# RENESAS TECHNICAL UPDATE

Product Category	MPU & MCU	Document No.	TN-RX*-A115A/E	Rev.	1.00
Title	Corrections to Manual regarding the USB 2.0 Function Module (USBa) in the RX630 Group		Information Category	Technical Notification	
Applicable Product	RX630 Group	Lot No.	Reference Document	RX630 Group User's Manual: Hardware Rev.1.60 (R01UH0040EJ0160)	
		All

This document describes corrections to section 31, USB 2.0 Function Module (USBa) in RX630 Group User's Manual: Hardware.

**Figure 31.8 Timing of BRDY Interrupt Generation**

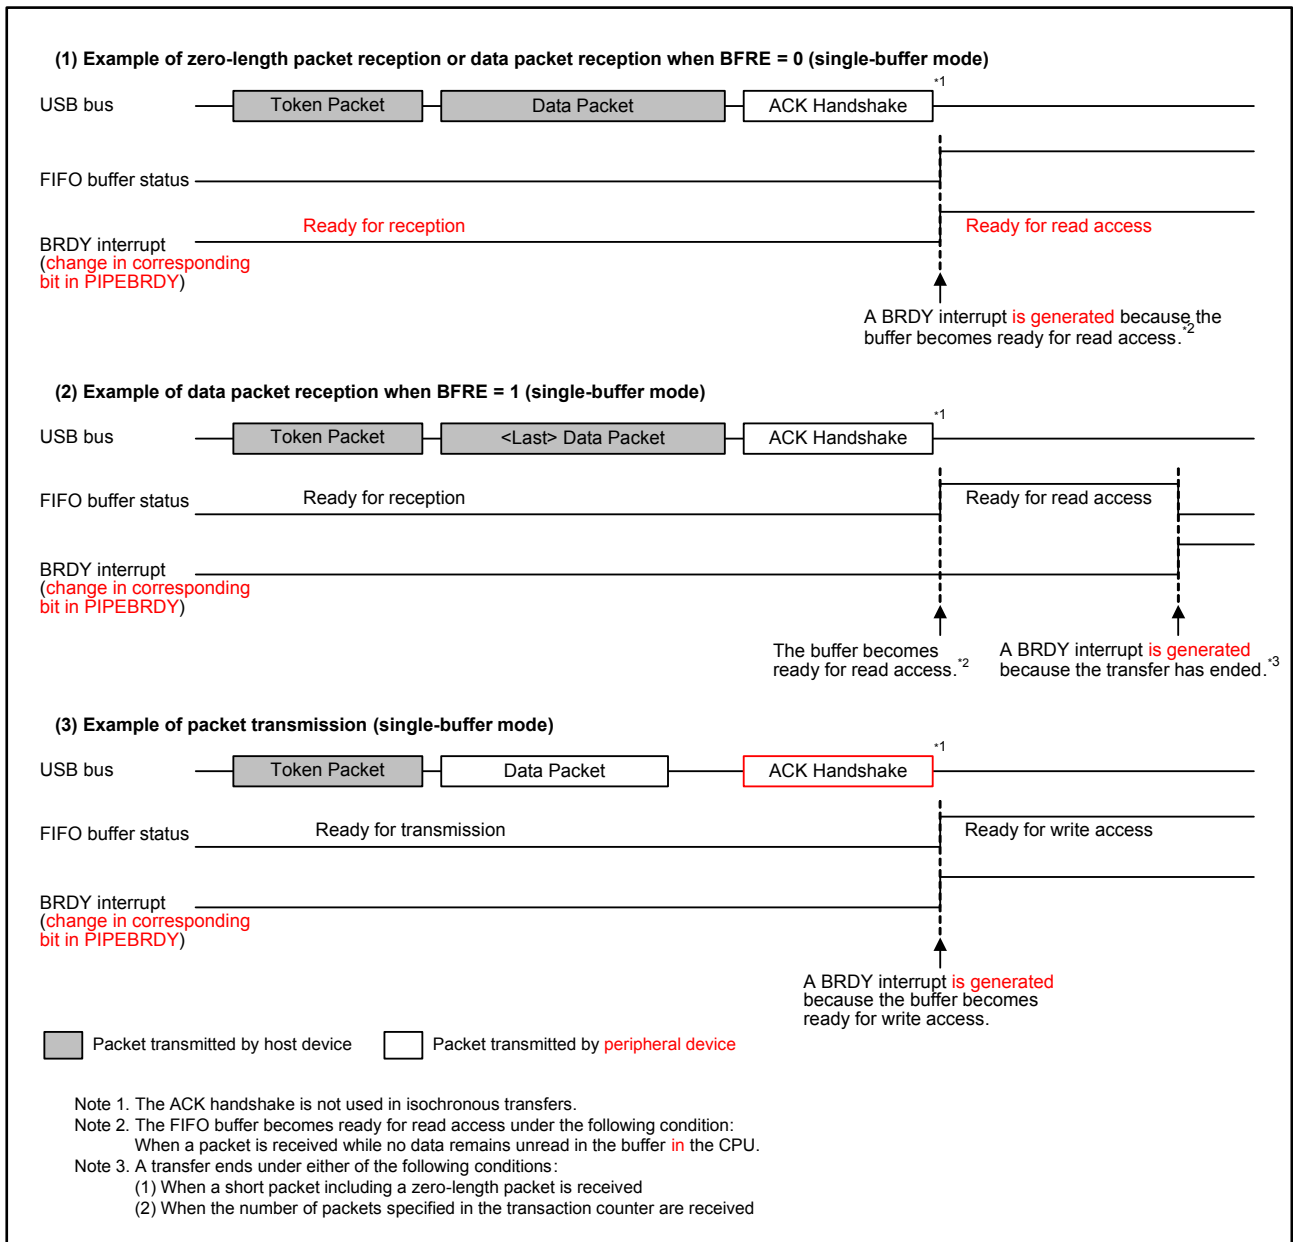
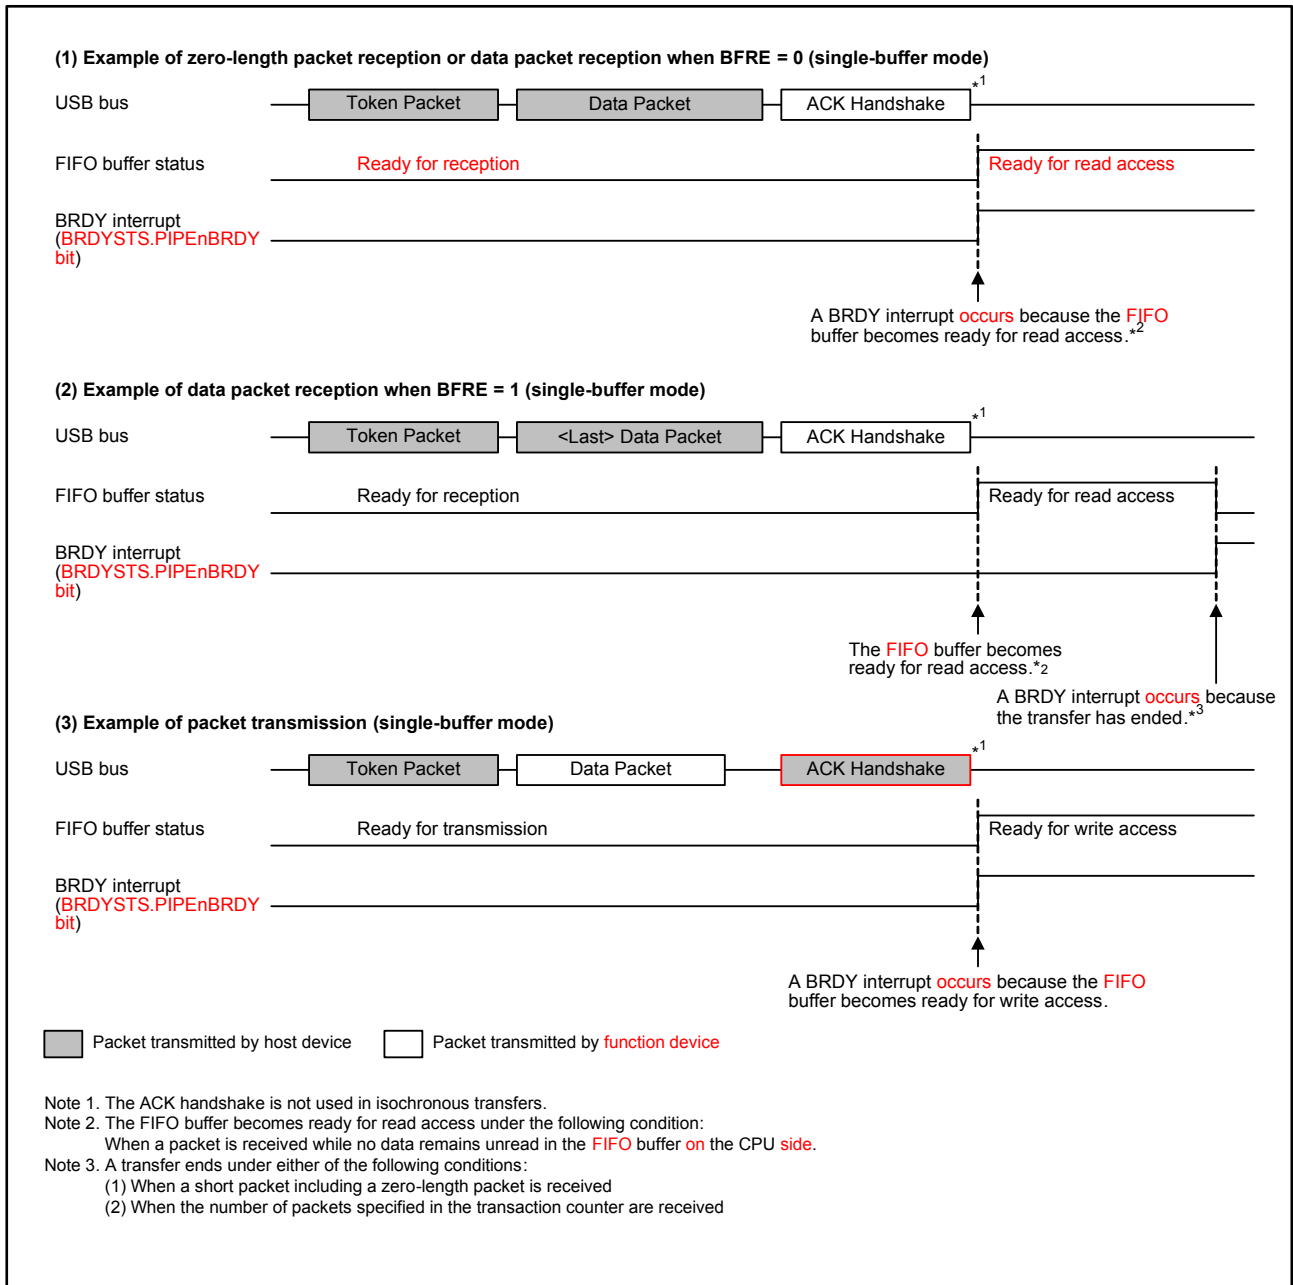
Figure 31.8 is corrected as follows:

**Figure 31.9 Timing of NRDY Interrupt Generation**

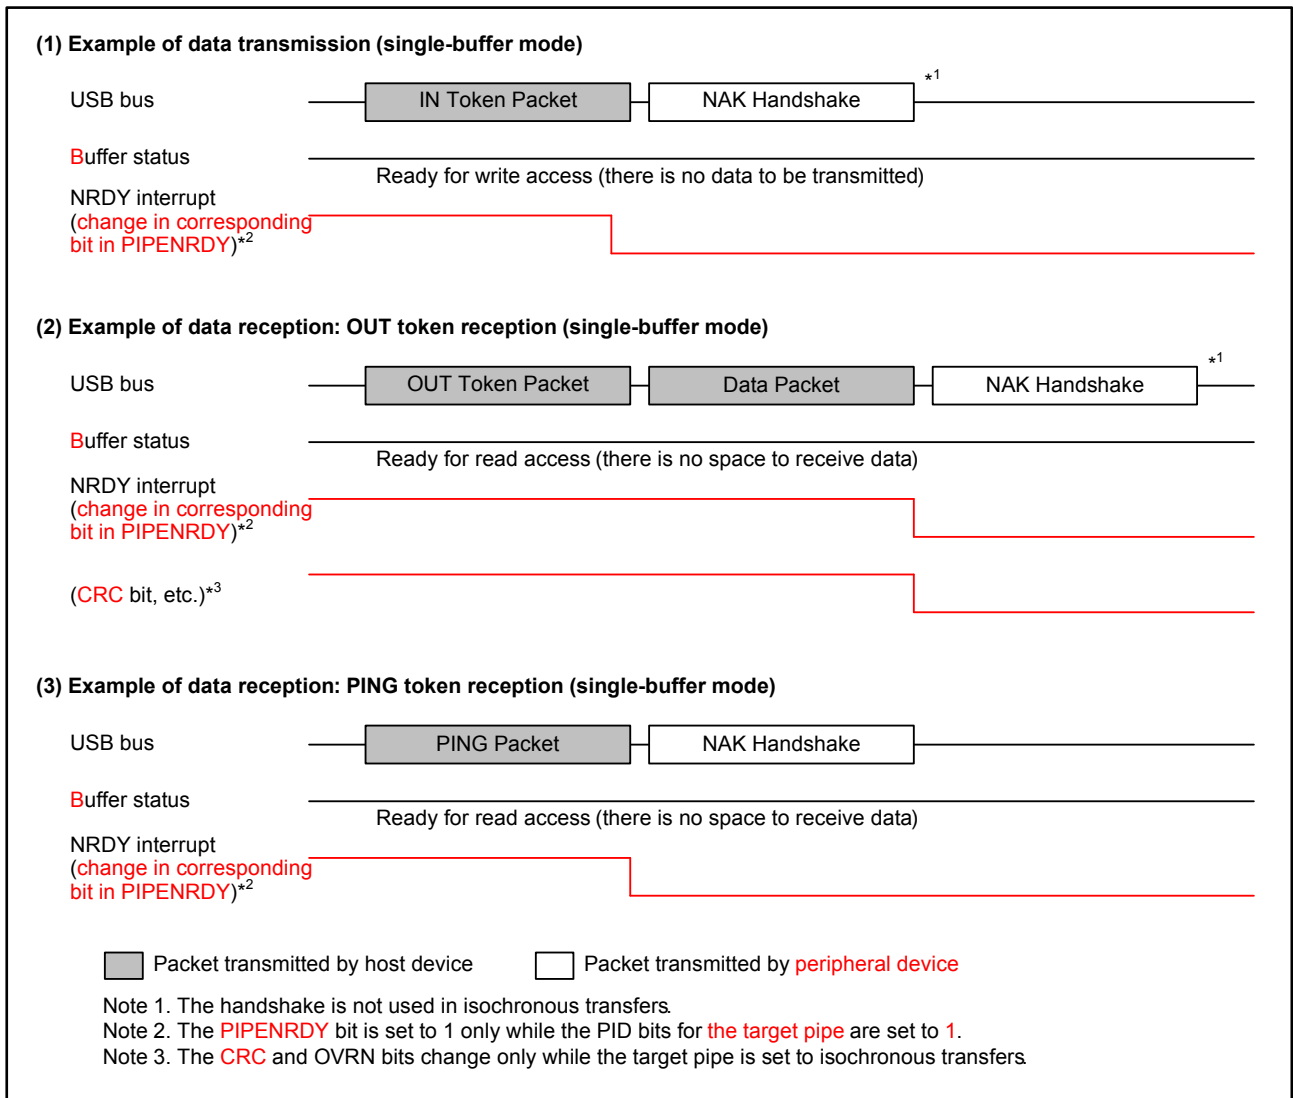
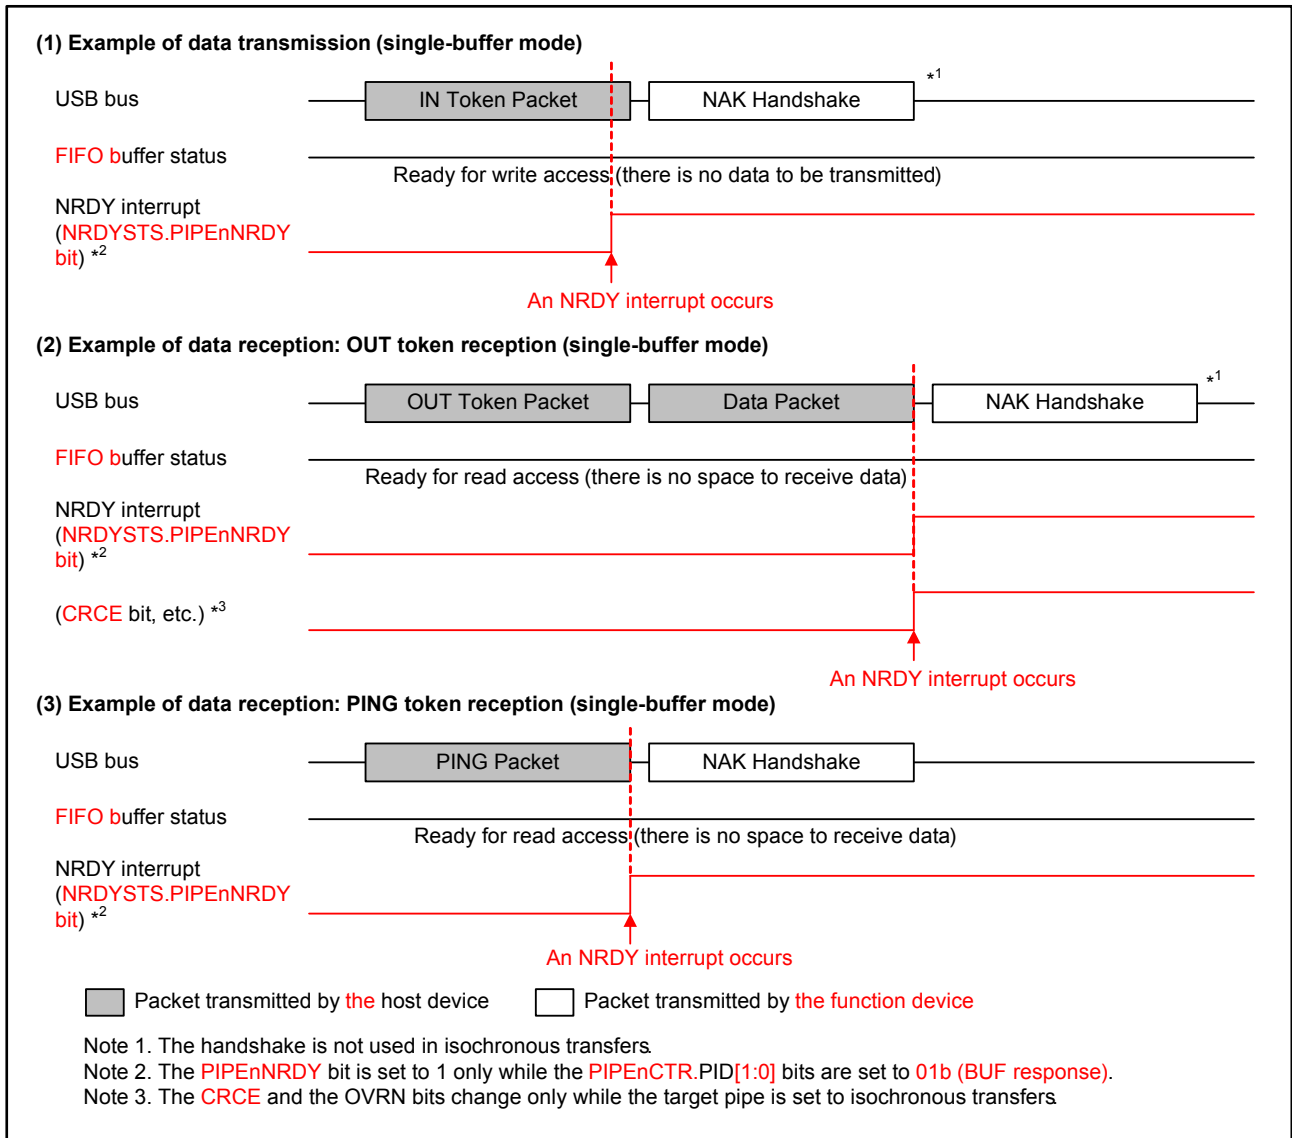
Figure 31.9 is corrected as follows:

**Figure 31.10 Timing of BEMP Interrupt Generation**

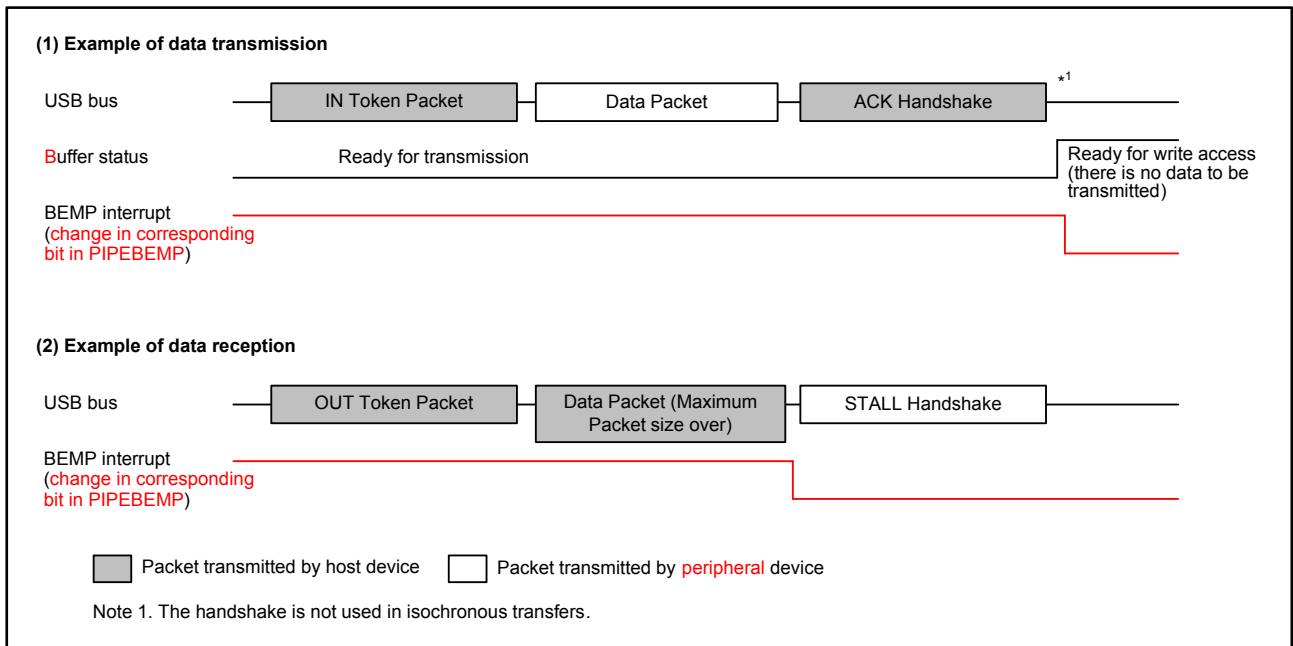
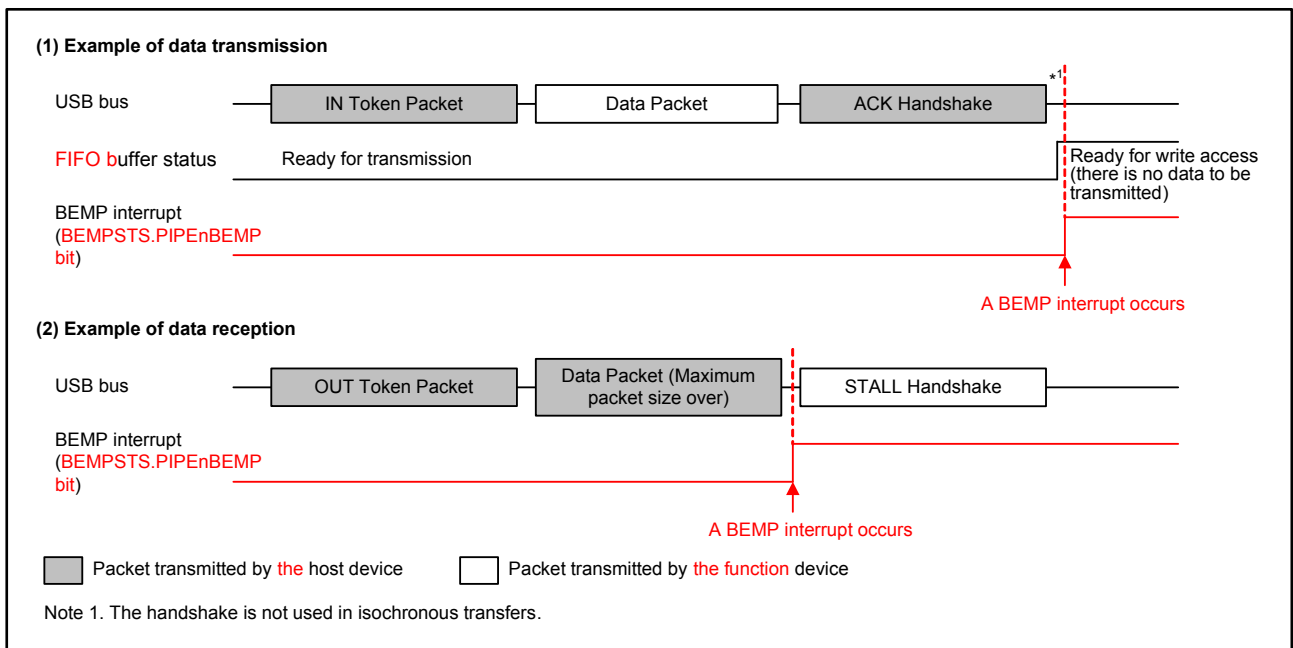
Figure 31.10 is corrected as follows:

Figure 31.13 Relationship between Frames and Expected Token Reception when IITV = 0

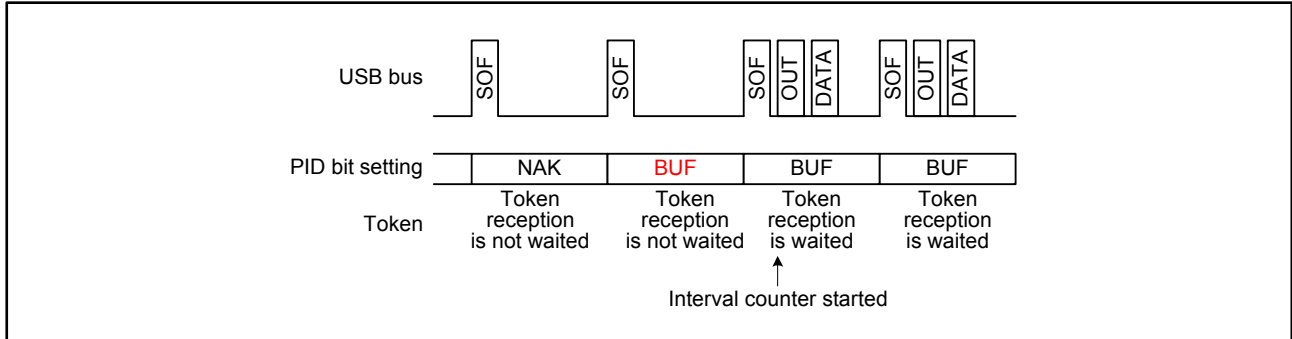
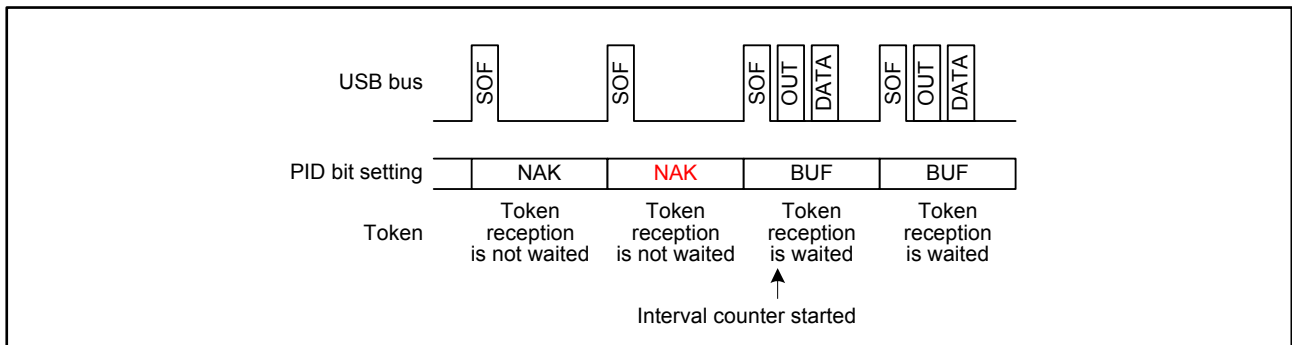
The descriptions for “When IITV = 0” in 31.3.9.3 (2) and Figure 31.13 are corrected as follows:

- When IITV = 0: The interval counting starts at the frame following the frame in which software has set the PID[1:0] bits for the selected pipe to BUF.

- When IITV = 0  
The interval counter starts when software has set the PID[1:0] bits for the selected pipe to BUF.
